# Access Compliance Report

## Public Rights-of-Way

### (Curb Ramps)

Intersection ID: 10014519	Main Street: UNIVERSITY_POINTE_BV	Cross Street: N/A	Location: E
ADA ID: 2433D72B3FA3	Ramp Type: PerpDiag	Initial Pass/Fail: Fail	Overall Compliance: No
Severity Score: 8.75			
Codes/Mitigation Info/Possible Solution		Field Measurements/Component Compliance

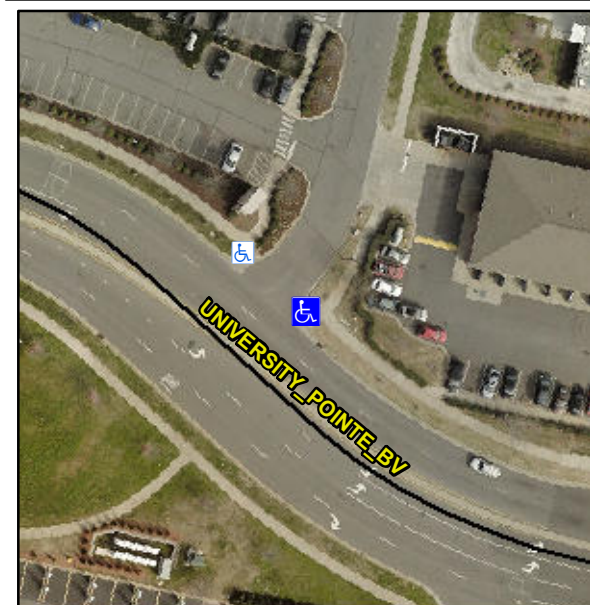
**Not Found, R304.5.1**

Compliance	Description	Data	Compliance	Description	Data
N/A	Ramp Length (in)	99.0	Yes	Ramp Slope (%)	7.2
No	Ramp Width (in)	44.0	Yes	Ramp XSlope (%)	0.2
N/A	Flare Type LT	N/A	N/A	Flare Type RT	N/A
N/A	Flare Slope LT (%)	N/A	N/A	Flare Slope RT (%)	N/A
N/A	Flare Traversable LT?	N/A	N/A	Flare Traversable RT?	N/A
N/A	Landing Length (in)	N/A	N/A	DWS Provided?	N/A
N/A	Landing Width (in)	N/A	N/A	DWS Contrast?	N/A
N/A	Landing Slope (%)	N/A	N/A	DWS Length (in)	N/A
N/A	Landing X Slope (%)	N/A	N/A	DWS Full Width?	N/A
N/A	Landing Curb? (Y/N)	N/A	N/A	DWS Offset (in)	N/A
N/A	Shared Landing?	N/A			
N/A	Gutter Ponding?	N/A	N/A	Gutter Slope (%)	N/A
N/A	Gutter Lip Ht (in)	N/A	N/A	Gutter X Slope (%)	N/A
N/A	Painted X Walk1?	No	N/A	Painted X Walk2?	No
	X Walk 1 Direction	To NW		X Walk 2 Direction	To SW
N/A	X Walk 1 Width (in)	N/A	N/A	X Walk 2 Width (in)	N/A
	X Walk 1 Slope (%)	3.4		X Walk 2 Slope (%)	0.5
	X Walk 1 X Slope (%)	3.5		X Walk 2 X Slope (%)	2.8

**Remove & Replace Curb Ramp With Two New Directional Ramps or Equivalent.**
